**Meeting Date:** Tuesday 17 July 2012  
**Location:** Committee Room 2, Level 5, Civic Centre, 1 Devlin Street, Ryde  
**Time:** 4.00pm

**NOTICE OF BUSINESS**

<b>Item</b>		<b>Page</b>
1	CONFIRMATION OF MINUTES - Meeting held on 19 June 2012 .....	2
2	3-5 TRELAWNEY STREET, EASTWOOD. LOTS A & B in DP 401296. Construction and strata subdivision of a mixed use development, consisting of a building with six retail /commercial tenancies; 61 units and basement parking for 108 cars. LDA 2011/0611. <i>INSPECTION 4.20PM / INTERVIEW 4.40PM</i> .....	26
3	7-9 RUTLEDGE STREET, EASTWOOD, LOT 23 DP 4231, LOT 24 DP 653568. Construction and strata subdivision of a mixed use building with six retail / commercial tenancies, 79 units and associated basement parking for 155 cars. LDA 2011/0612. <i>INSPECTION 4.20PM / INTERVIEW 4.45PM</i> .....	140
4	28 GERARD STREET, GLADESVILLE. LOT 40 DP 10598. Local Development Application for the erection of a 2 storey dual occupancy (attached). LDA2011/328. <i>INTERVIEW 4.50PM</i> .....	260
5	78 HERMITAGE ROAD, WEST RYDE. Lot 8 DP 24562. Local Development Application for Change of use to manufacturing and warehousing of pool/spa products and advertising signs.

**Diagram 1:** North Elevation:

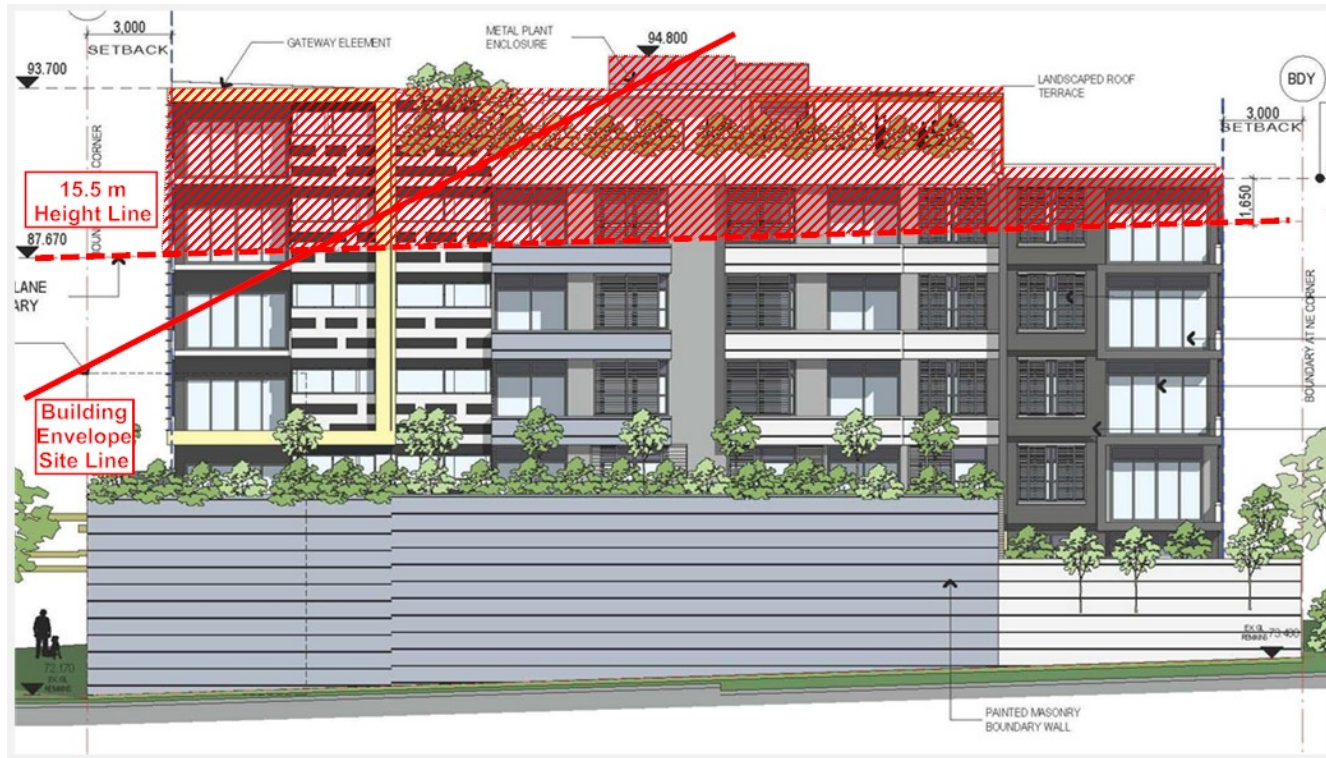
The maximum building height will be 21.15m and located at the northeast building corner in the location of proposed Unit No. 504 (to the west side where the survey indicates an RL of 72.55) and exclusive of the upper, stepped section of the sloped roof. This represents a variation to the prescribed 15.5m height of 5.65m (36.45%). The following diagrams demonstrate the height non-compliance. If the stepped roof is included the height will be approximately 21.35m which represents a variance of 5.85m.

Area of non-compliance with maximum 15.5m RLEP 2010 Height Standard

**Diagram 3:** North Elevation:

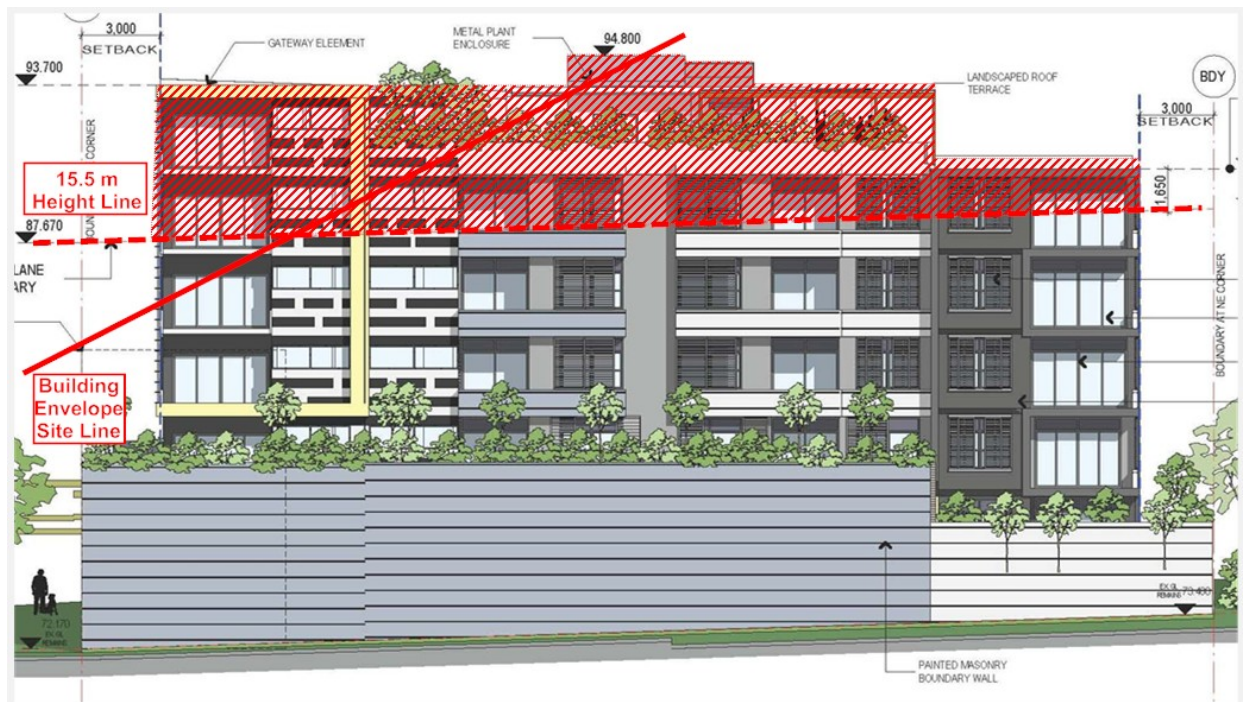
The proposal does not comply with the envelope control as indicated in the diagrams below.

— Building Envelope of RDCP 2010 (measured from Trelawney Street boundary)

**Diagram 1: West Elevation -**

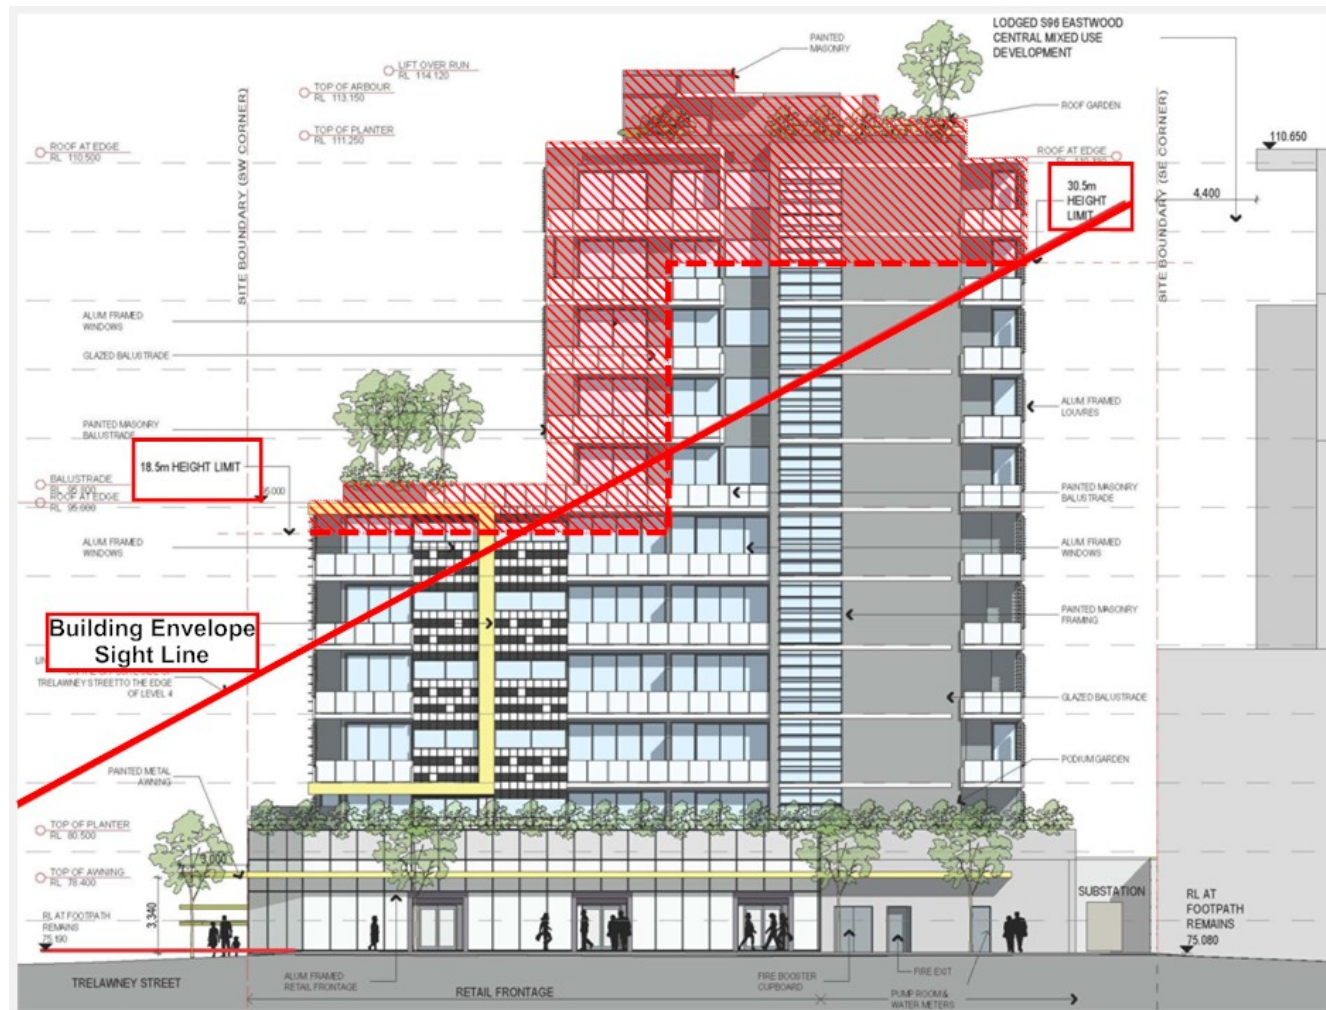
The above non-compliances are demonstrated on the following diagrams.

Area of non-compliance with maximum 18.5m and 30.5m LEP Height Standards

**Diagram 2: North Elevation -**

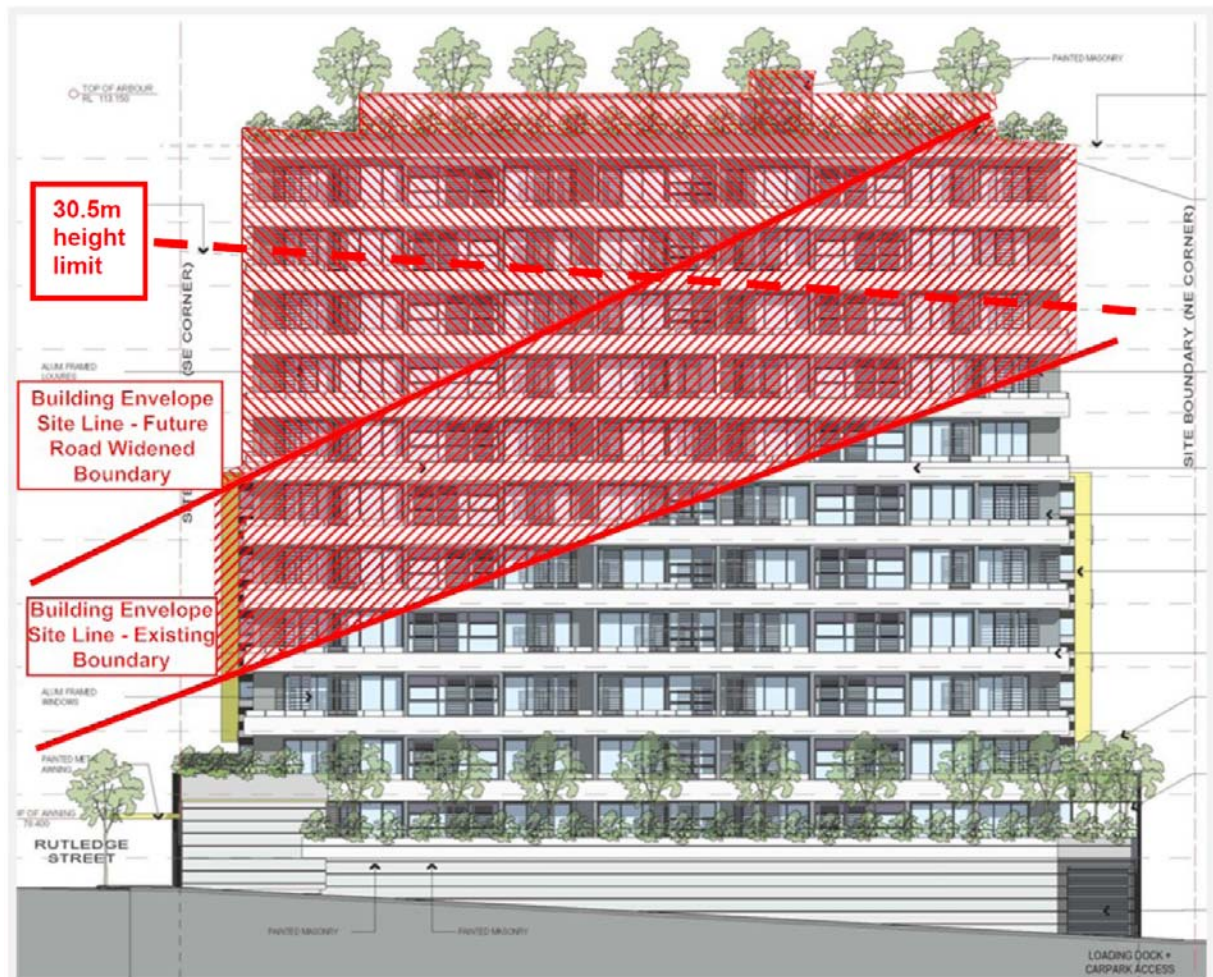
The proposal does not comply with the envelope control as indicated in the diagrams below.

Area of non-compliance with maximum 18.5m and 30.5m LEP Height Standards

**Original Plans – Roof Plan:**

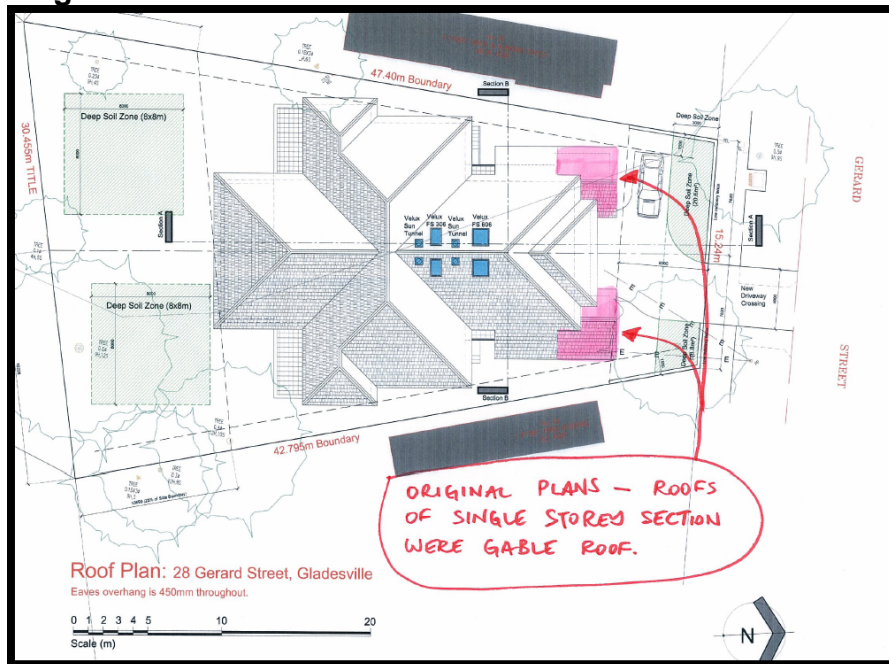
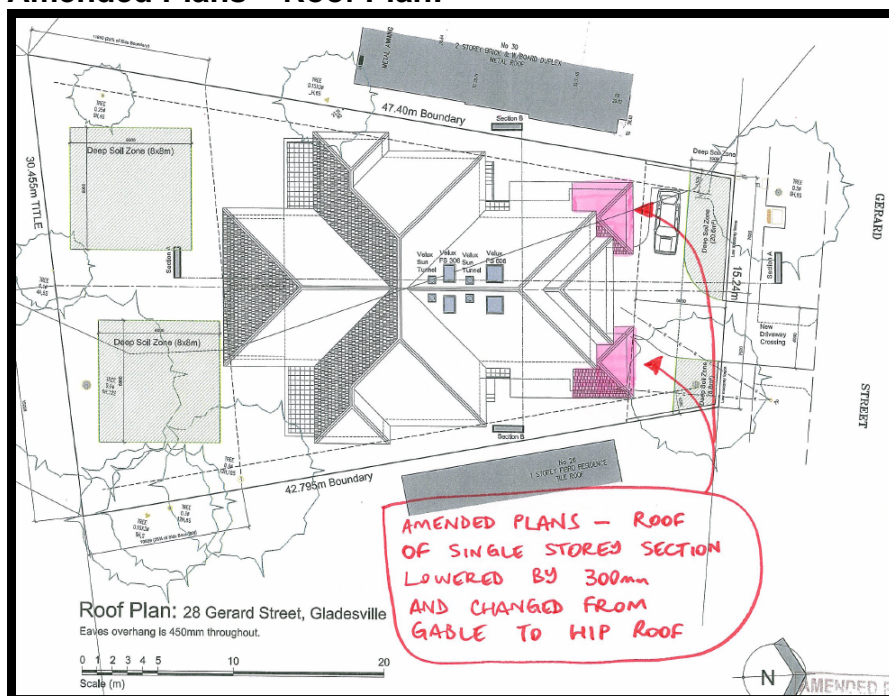
At the mediation meeting, the applicant had suggested the following changes to improve solar access available for the neighbours (see plans below):

- Lowering the height of the roof over the single storey entries by 300mm; and
- Changing the roof configuration (over the single storey entries) from a gable roof to a hipped roof.

**Amended Plans – Roof Plan:**

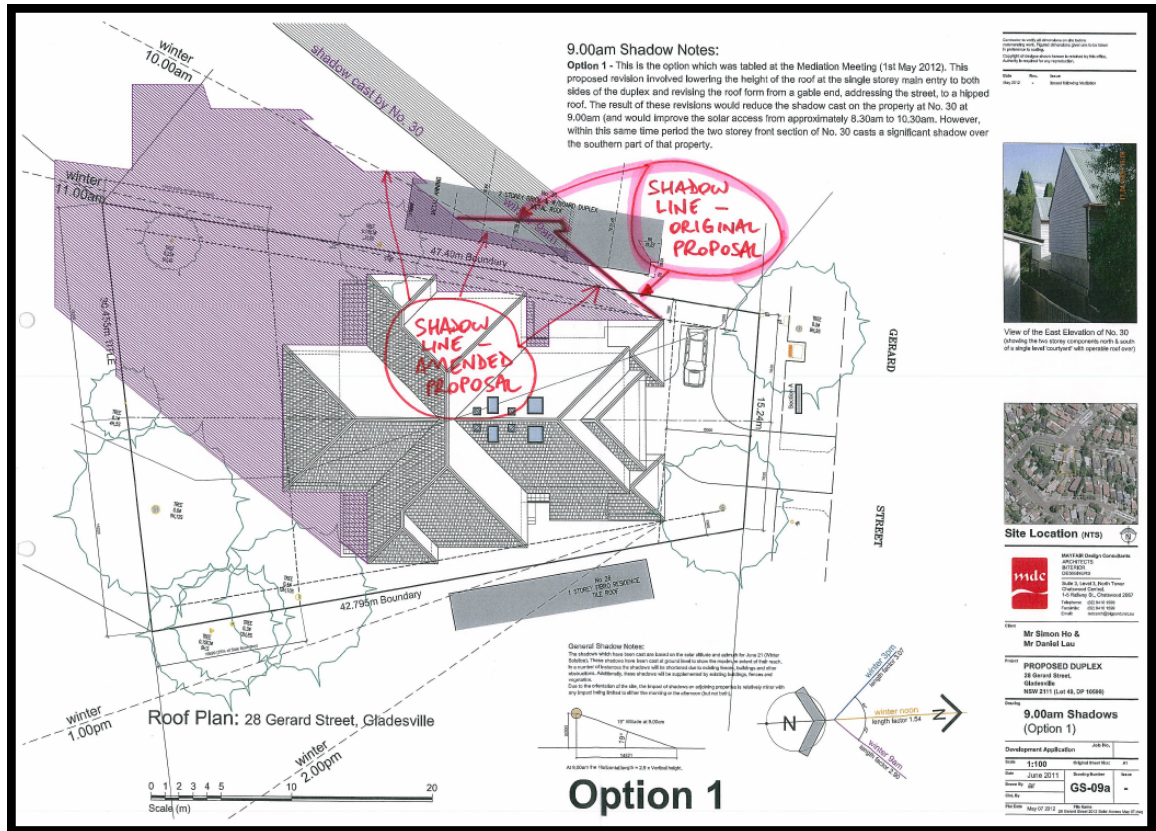
The design amendments provided by the applicant as agreed during the mediation meeting process has resulted in improved solar access to the neighbour’s internal courtyard at 9am.

Given that these design changes have been made to the front entry of both dual occupancy units in this development, it is also expected that there will be similar improvements in terms of afternoon solar access to the neighbour to the east (No 26 Gerard).
